**FINAL STATEMENT OF REASONS
FOR
PROPOSED BUILDING STANDARDS
OF THE
OFFICE OF THE STATE FIRE MARSHAL**

**REGARDING THE 2016 CALIFORNIA BUILDING CODE
CALIFORNIA CODE OF REGULATIONS, TITLE 24, PART 2**

~~FIGURE 11.2.3.2.3.1 Design Area Reduction for Quick Response Sprinklers~~

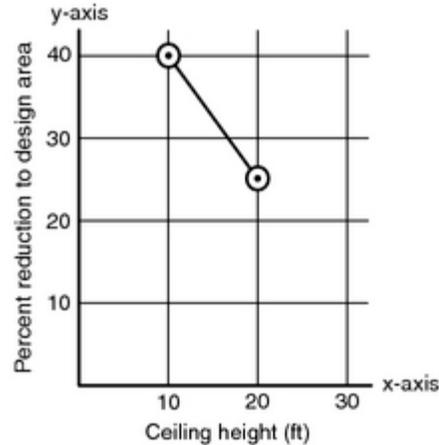
Comment: Commenter states "the 2015 and 2016 editions of NFPA have recently been published and are now available. The SFM has reviewed these most current editions of NFPA standards and has determined that the adoption of the new edition is appropriate. The SFM has reviewed these most current editions of NFPA standards and has determined that the adoption of the new edition is appropriate. At the time of the Code Advisory Committee (CAC), the 2016 NFPA standards had not been published or approved by the NFPA Standards Council. SFM advised the CAC that it was the SFM's intention to adopt the latest editions of the NFPA standards, if they are finalized by the Standards Council prior to the conclusion of SFM's 45 day public comment period. The CAC concurred with the SFM's course of action."

Response: The SFM has revised the proposed modification during the 15-day comment period to adopt the latest editions of the NFPA standards. Revised text and reason statement for below:
